RECALL 26V603 REMEDY INSTRUCTIONS

FOREST RIVER	Make(s): GRAND SPORT GT Model(s): GGC45CB-600 Model Year(s): 2026 - 2027	Repair Code: RC-744-01-00-004859 Allotted Time: 1.00 HRS. Inspection Code: RC-744-05-00-004858 Allotted Time: .10 HRS.
	Concern: The "Engine Pre-Heat" option was improperly installed.	Photo(s) Required: NO Prior Authorization Required: YES Part(s) Kit Number: F100898875 Part(s) Return: FIELD DESTROY

TECHNICAL BULLETIN

Heating Systems	August 10, 2026	Bulletin Identification No.: ETB047-10
Release Type: Public

2041-62 RV-C REMOTE OPERATION CABLE BETWEEN ZONE BOARD AND RV-C NODE BOARD.

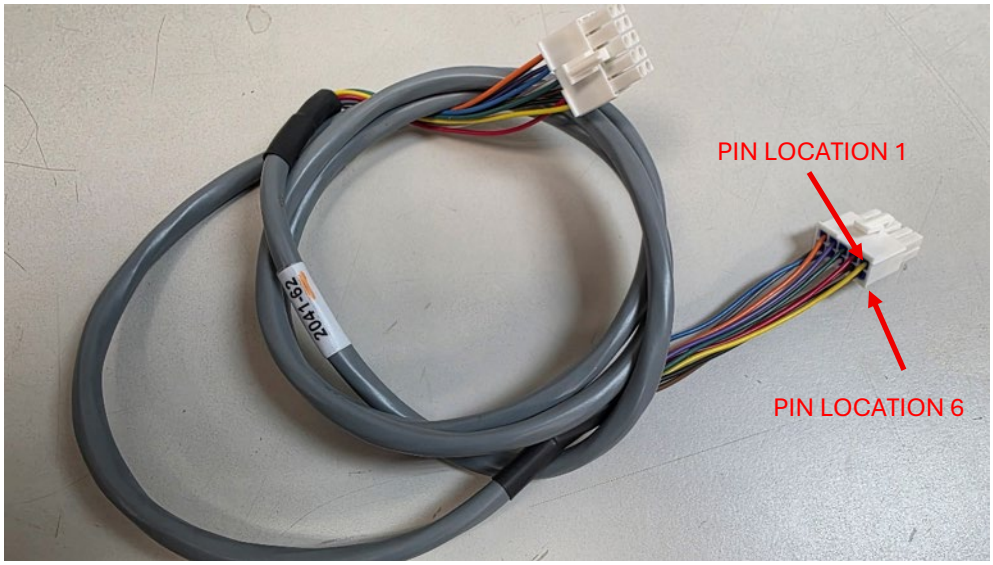
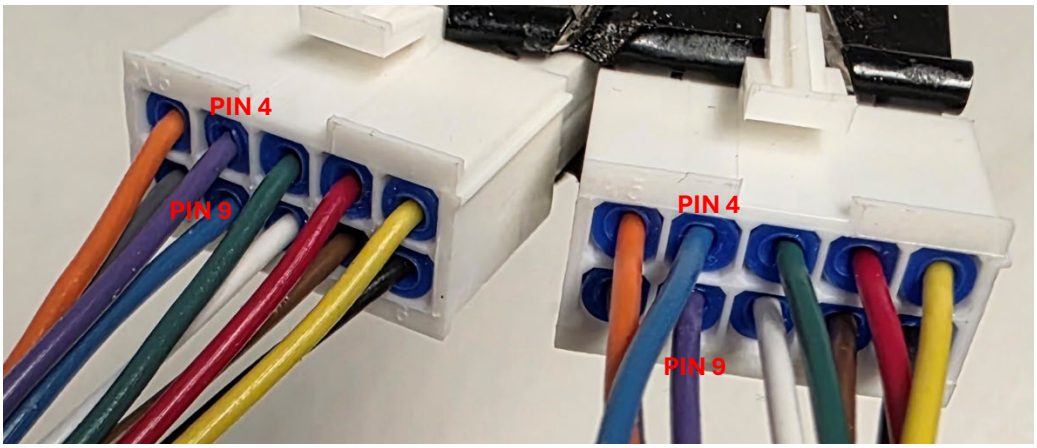
Harness pinout:

NOTE THE DIFFERENCE IN PIN CONFIGURATION BETWEEN LOCATIONS 4 AND 9 ON THE 770580-1 CONNECTORS.

STEP 1: REPLACE OR REPIN 2041-62 AT THE OASIS (REFERENCE ATTACHED DOCUMENTS); THE HARNESS IS LOCATED IN THE STORAGE BAY TO THE RIGHT OF THE OASIS BAY. IT IS IN THE UPPER LEFT CORNER OF THE STORAGE BAY

ENGINE PRE-HEAT HOSE CONNECTIONS

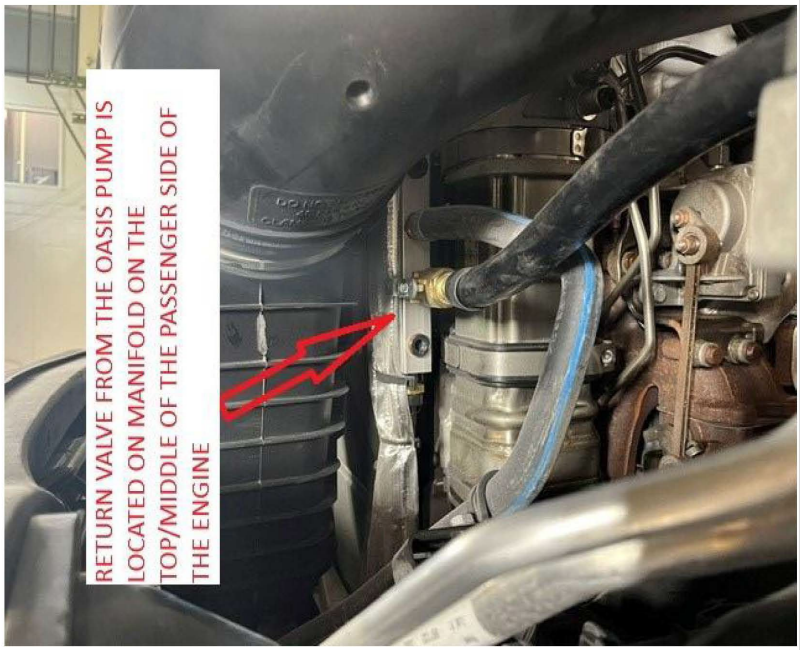
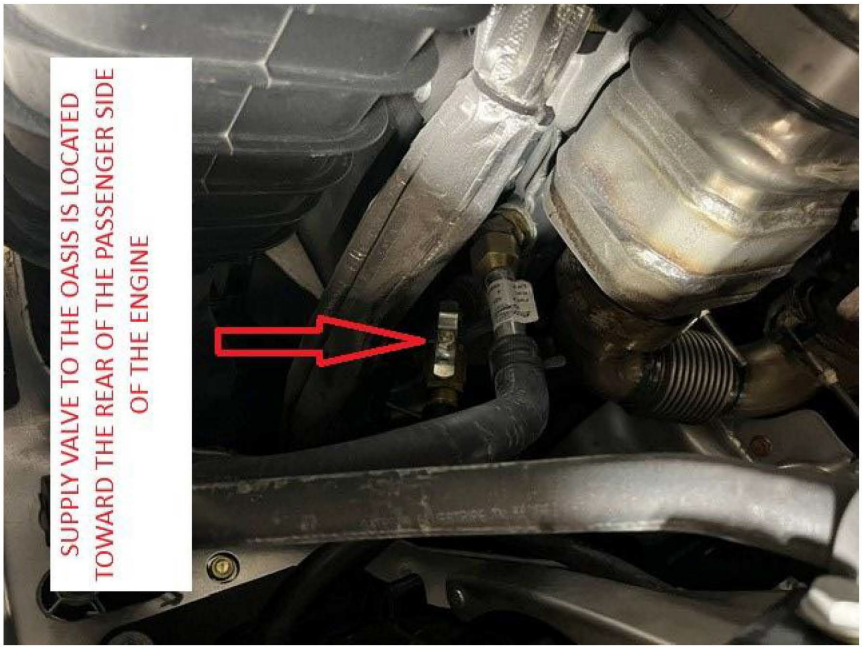
STEP 2: RE-ROUT HOSE FROM *RETURN* TO *SUPPLY SIDE* OF THE PUMP (REFERENCE ATTACHED DRAWING);

The 2041-62 harness should be pinned as follows:

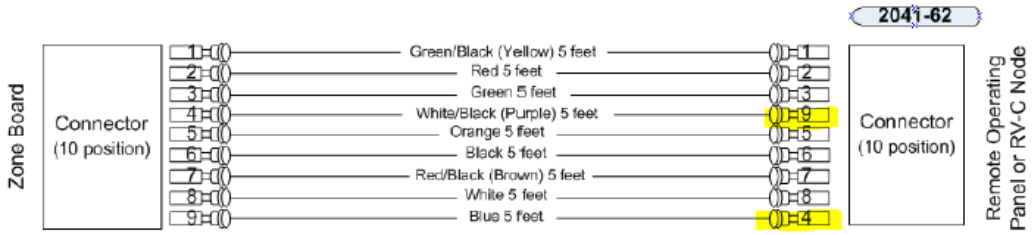
Prior to August 10, 2026, the 2041-62 harness could have been manufactured with pins 4 and 9 incorrectly pinned. This will result in the engine pre-heat function not working (i.e. if the system is up to temperature and the user calls for the engine pre-heat function at the main touchscreen interface, the engine pre-heat LED on the zone board will not turn ON, and the engine pre-heat pump will not function).

If the 2041-62 harness installed in the system is not pinned as above, it will need to be corrected (swap pins 9 and 4 on one of the 10 pin connectors), or swapped out with a new 2041-62 harness.
